538 KARANGAHAPE ROAD, NEWTON: BUN60427502 S92 REQUEST RESPONSE TABLE

30 July 2024

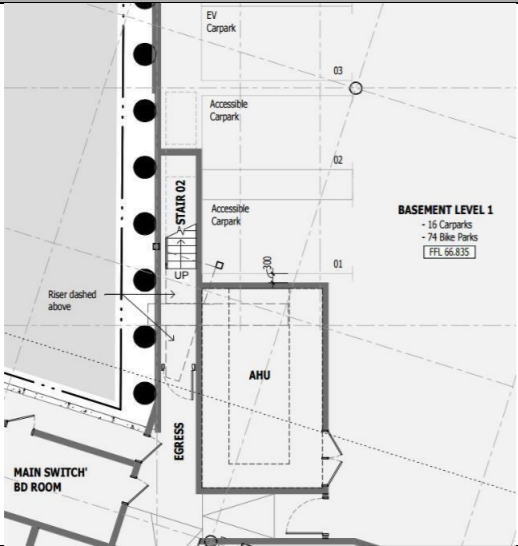
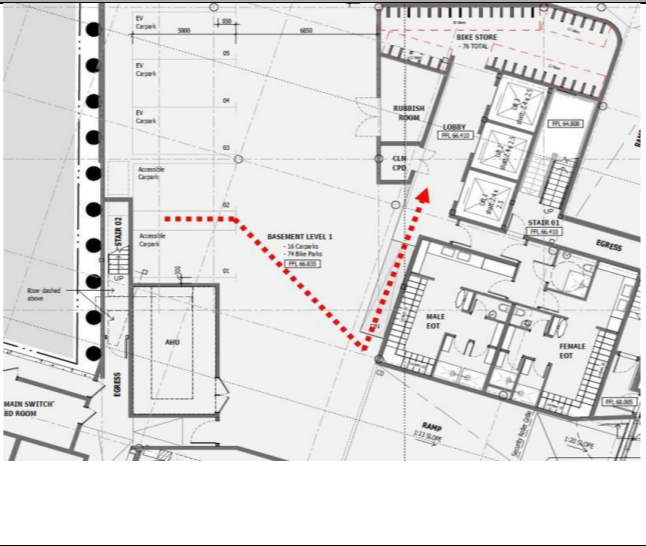
14.	<p>The scope of the study area adopted for the crash analysis and the spread of crashes throughout the study area are not entirely clear from the information provided in the TA. While the TA references particular intersections covered in the analysis, it is not clear as to whether the analysis covers a sufficiently wide area, including mid- block sections of road.</p> <p>The proposal is expected to result in high concentrations of new vehicle activity at the intersection of Karangahape Road / Gundry Street and high concentrations of pedestrian activity at this intersection and at the new pedestrian building entrances on Karangahape Road and Abbey Street. An appropriate scope for the crash analysis should therefore include:</p> <ul style="list-style-type: none"> a. Karangahape Road between (and inclusive of) its intersections with Newton Road and Edinburgh Street, noting that there are no formalised intermediate pedestrian crossing opportunities between these two intersections. b. Gundry Street, at least as far south as its 	<p>Please see letter from Commute Transportation Consultants (CTC) which addresses this question.</p> <p>CTC note that the vehicle and pedestrian network is able to operate safely and as such no additional mitigation measures are considered to be necessary.</p>	Noted. Satisfied

Request	Response / Action	Council Response 30 th April	Applicant Response 30 July
	<p>intersection with Abbey Street</p> <p>C. Abbey Street, between Newton Road and Gundry Street</p> <p>Please provide further detail accordingly and if appropriate, consider scope for mitigation measures, such as additional pedestrian crossing points to cater for desire lines accessing the new development.</p>

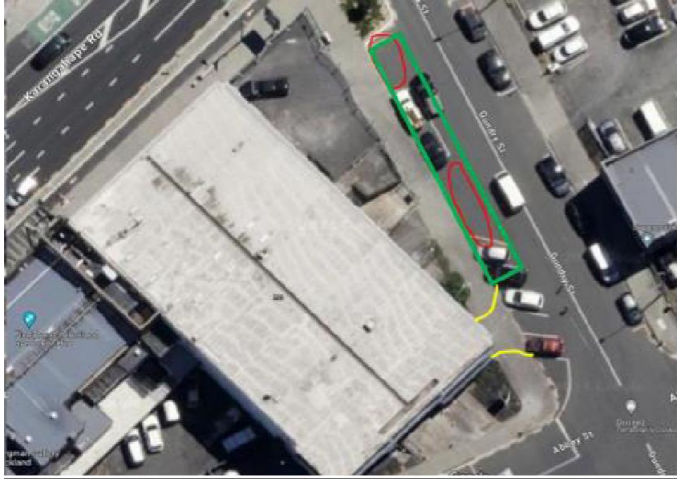
Auckland Transport			
<p>25. The transport assessment notes a vehicle trip generation of over 2000 vehicles per day to the site. There is no back berm present between the property boundary and the public footpath. Based on the high trip generation rate and the lack of back berm, AT is concerned</p>	<p>Please see letter from CTC which addresses this question. CTC confirm that there is provision for a 2.5m by 2m pedestrian visibility splay at the vehicle entrance and that this is satisfactory to achieve a safe intervisibility window between pedestrians and vehicles.</p>	<p>There is still a safety concern regarding the visibility splays. Please confirm that the applicant will propose a condition of consent requiring that a speed hump on the exit lane?</p>	<p>The revised application plans now include a speed hump on the exit lane and the detailed design of this can be conditioned.</p>

Request	Response / Action	Council Response 30 th April	Applicant Response 30 July
	<p>that pedestrian and vehicle intervisibility is affected. The traffic assessment notes that a pedestrian visibility splay is provided on the northern side of the proposed vehicle crossing to assist in achieving pedestrian and vehicle intervisibility. The splay is proposed at 2.9m x 1.1m. Based on the proposed trip generation rates, the proximity of the crossing to an intersection and non-compliance with the required vehicles waiting platform, the size of the pedestrian visibility splay provided is considered insufficient to address pedestrian safety concerns. Please provide additional information in accordance with E27.8.2(8)(a) on how pedestrian and vehicle intervisibility at the proposed vehicle crossing can be avoided, remedied or mitigated.</p> <p>Advice note: The NZTA Pedestrian Planning and Design Guideline recommends a 5m x 2m pedestrian visibility splay for vehicles crossings generating more than 200 vehicles trips per day. This development will exceed the 200-trip number.</p>	<p>In addition, they note that <i>“In regard to the proposed waiting platform, which measures 4.4 metres in length and slopes down toward the site boundary, it is noted that an 85th percentile vehicle will be able to have its wheels fully positioned on the 1:20 (5%) gradient while remaining within the site boundary (front of body to rear wheels measures 3.72 metres as per Figure E27.6.3.3.2 of the Unitary Plan). It is understood that the intent of the Unitary Plan rule to provide 6.0 metres is for heavy vehicles with longer wheelbases, and as no heavy vehicles will be accessing the site, the 4.4 metre long platform is considered to be appropriate such that it would not impact pedestrian intervisibility.</i></p> <p><i>A speed hump in the exiting lane may assist with ensuring that exiting vehicles are doing so at low speeds, and the combination of the above is considered to be a satisfactory outcome for safety at the access.</i></p>

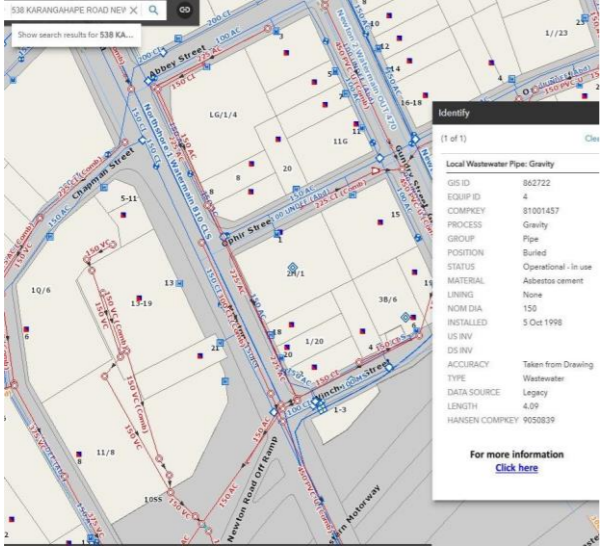
27.	<p>The proposed vehicle crossing is across multiple existing on-street parking spaces on Gundry Street. Parking in this area is in high demand and there is a concern with the proposed loss of these spaces. It is also noted that the site has 4 existing vehicle crossings that will be made redundant through this proposal.</p> <p>a. Please confirm if the car parking spaces proposed to be</p>	<p>Please see letter from Commute Transportation Consultants (CTC) which addresses this question and includes a potential revised layout consistent with these requests.</p> <p>The applicant agrees in principle with the reinstatement and is happy to discuss and revise the CTC concept design in line with Auckland</p>	<p>AT requests if the applicant will propose a condition of consent for these works?</p>	<p>A condition is accepted/offered by the applicant regarding the detailed design of the street / parking layout and reinstatement as part of the proposal. .</p>

Request	Response / Action	Council Response 30 th April	Applicant Response 30 July
<p>removed as a result of the new vehicle crossing will be reinstated.</p> <p>b.If these spaces will not be reinstated, please provide an assessment in accordance with Objective E27.2(3) Policy E27.3.3(f) of the effects of the loss of on-street parking arrangement on the western side of Gundry Street.</p> <p><i>Advice note: all four redundant vehicle crossings will need to be reinstated by the applicant to the kerb, channel and footpath. The No Stopping at Any Time line markings in front of the redundant Abbey Street vehicle crossings will need to be removed by the applicant. It is recommended that these reinstatement requirements are accepted as a condition of consent with the design detail considered at subsequent design stages. Anticipated required changes to the western side of Gundry Street (along the site's frontage) include:</i></p> <ul style="list-style-type: none"><i>•The removal of angled parking spaces to allow for the vehicle crossing,</i><i>•Reinstatement of both redundant vehicle crossings on Gundry Street,</i><i>•Provision of angled parking from the northern kerb buildout to the proposed vehicle crossing without adversely effecting visibility for vehicles leaving the site</i><i>•It is likely that the applicant is requested to remove the existing motorbike parking bay.</i> <p><i>The image below illustrates a concept of how the reconfiguration could work, with the green bar indicating AT's preferred space for paid angled parking. Please note this figure is for reference only to guide a design by the applicant, and it does not indicate that a similar design will be approved in future.</i></p>	<p>Transport requirements.</p>

Request	Response / Action	Council Response 30 th April	Applicant Response 30 July
	 <p><i>AT has requested that the applicant agree to the reinstatement mentioned above, with a concept design being submitted. This would assist in streamlining the EPA process.</i></p>			
Development Engineer
